MICHAEL ATHANAS & ASSOCIATES
LICENSED SOIL SCIENTIST
561 Ennis Rd.
Weddington, NC 28173
(704) 576-3887

Reference: Data Sheet for Anniston SD, Lot 136
House Footprint: 70' x 90'
Building Setbacks: 35' front/rear, 15' side
Water Source: Private well
Number of Bedrooms: 5/600 GPD
Predetermined LTAR: 0.275 GPD/FT2 (ICHD)
Proposed System Type: PPBPS
Proposed Repair System Type: PPBPS
Distribution: Low Pressure-CVB
Flow per Orifice: 0.59 GPM
Orifice Size: 3/16"
System Flow: 50.2 GPM
Dosing Volume: 306 gallons
Pump Run Time: 6.1 minutes
Elevation Head: 0.8'
Friction Head: 2.1'
Pressure Head: 2'
Total Dynamic Head: 2.9'
Supply Line Length: 45'
Septic/Pump Tank Size: 1500/1500 gallons
Proposed Trench Bottom: 36"

SOIL/SITE EVALUATION
for ON-SITE WASTEWATER SYSTEM

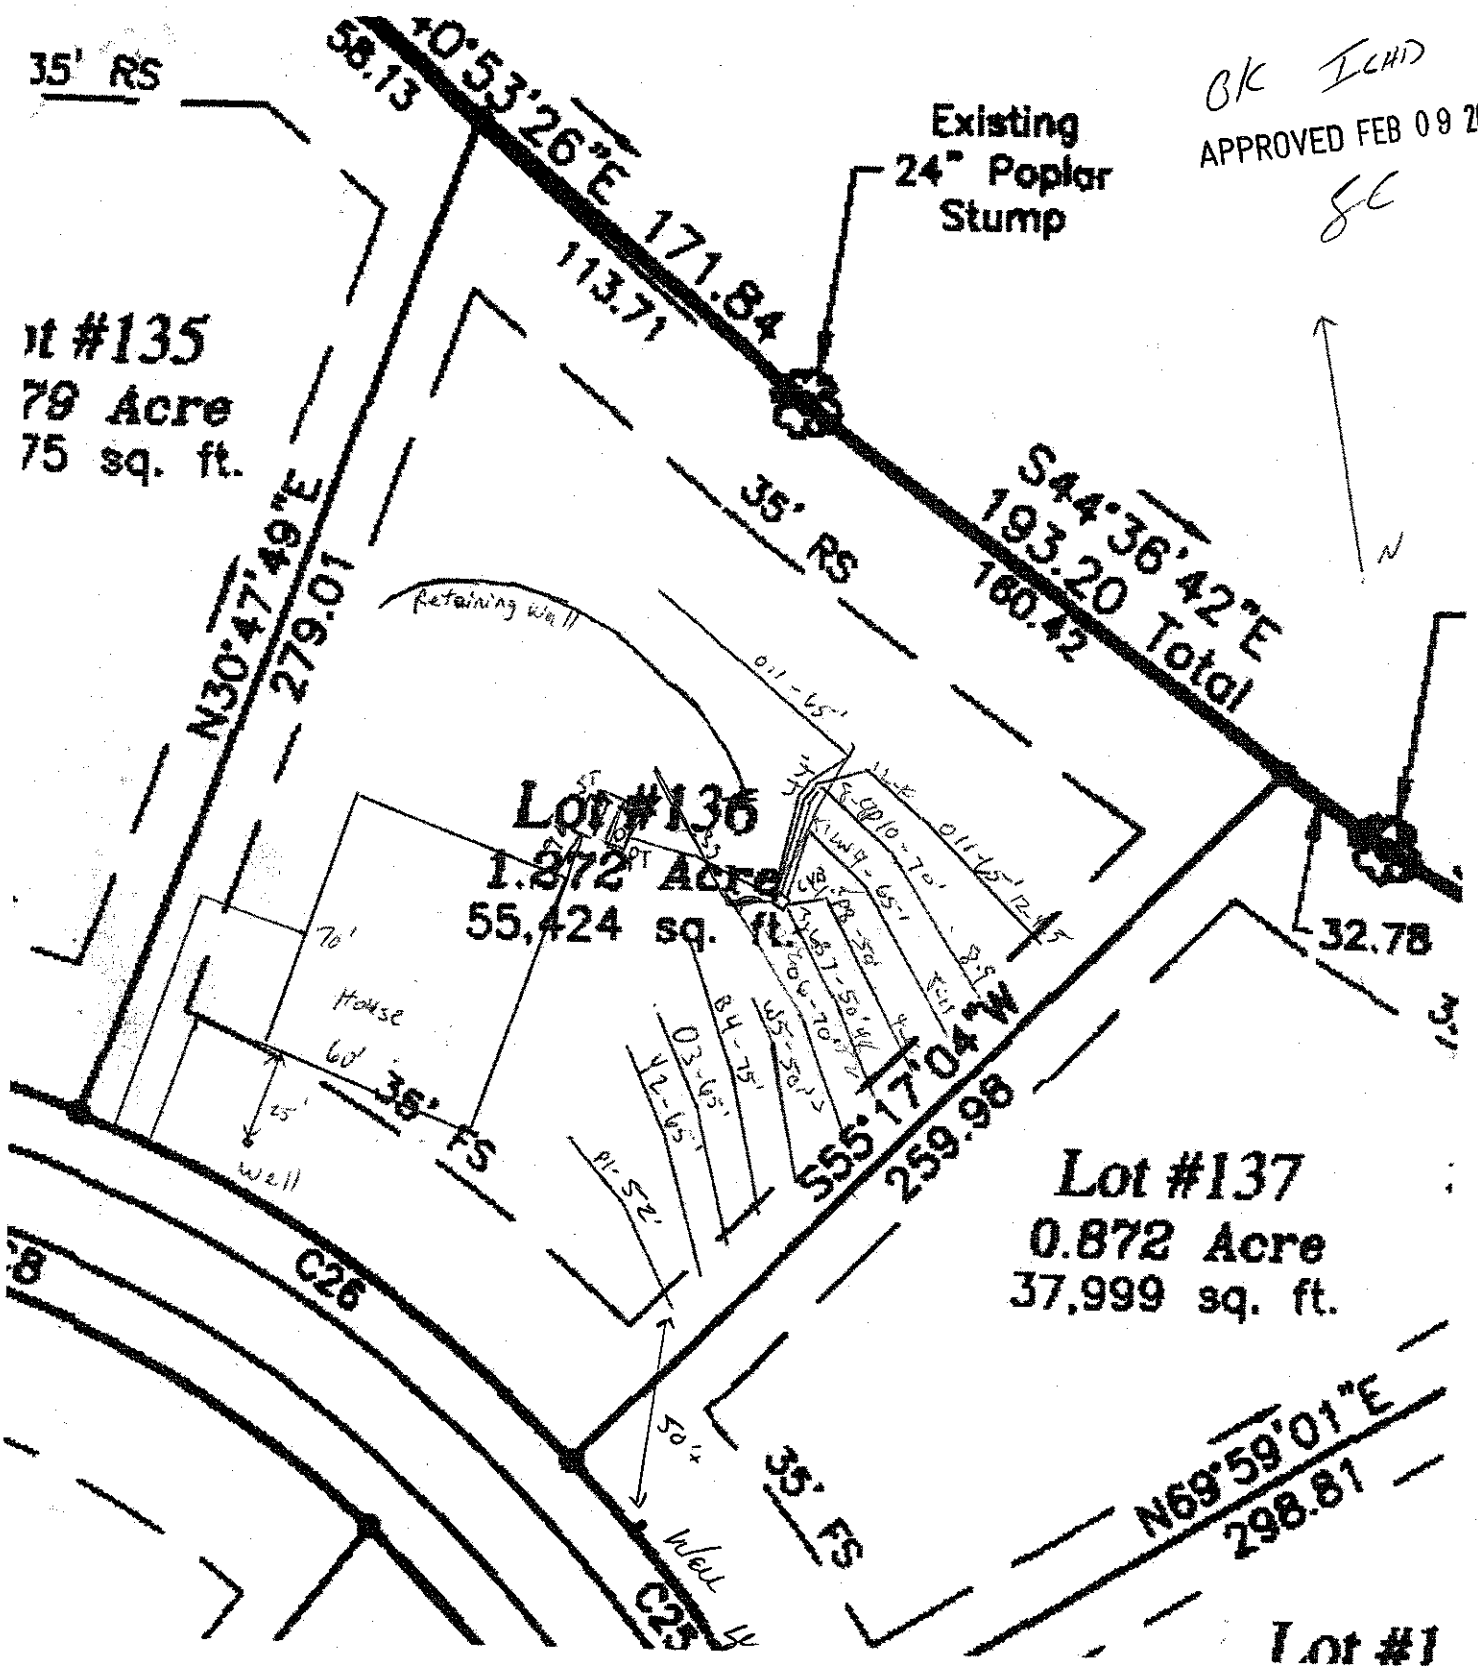
Comments:
This system is being redesigned because the developer is building a retaining wall to bring the house higher in elevation. MA&A merely adjusted the previous lay out to meet the setbacks from the proposed retaining wall. The previous flags are still in place. This system is changing from a 25% Reduction system to a PPBPS. The house box is not marked because the area of the house is being graded. The retaining wall has been located by a surveyor. Please call MA&A prior to site visit.

Line	Design Length	# of Panels	Actual Length	Elevation
Pink 1			52'	8.8'
Yellow 2			65'	11.3'
Orange 3			65'	13.5'
Blue 4			75'	15.6'
White 5			50'	16.9'
Orange 6			70'	18.5'
Blue 7	**50'**	**12**	**58'**	**20.0'** ✓
Pink 8	**50'**	**12**	**50'**	**21.5'**
White 9	**65'**	**15**	**70'**	**23.2'**
Pink 10	**70'**	**16**	**87'**	**26.8'**
Orange 11	**65'/65'**	**15/15**	**147'**	**29.3'** ✓

Initial System: 365' **Repair System:** 377'
Pump Tank: 15.8' **House Corner:** 14.4' **Benchmark:** 3.7'
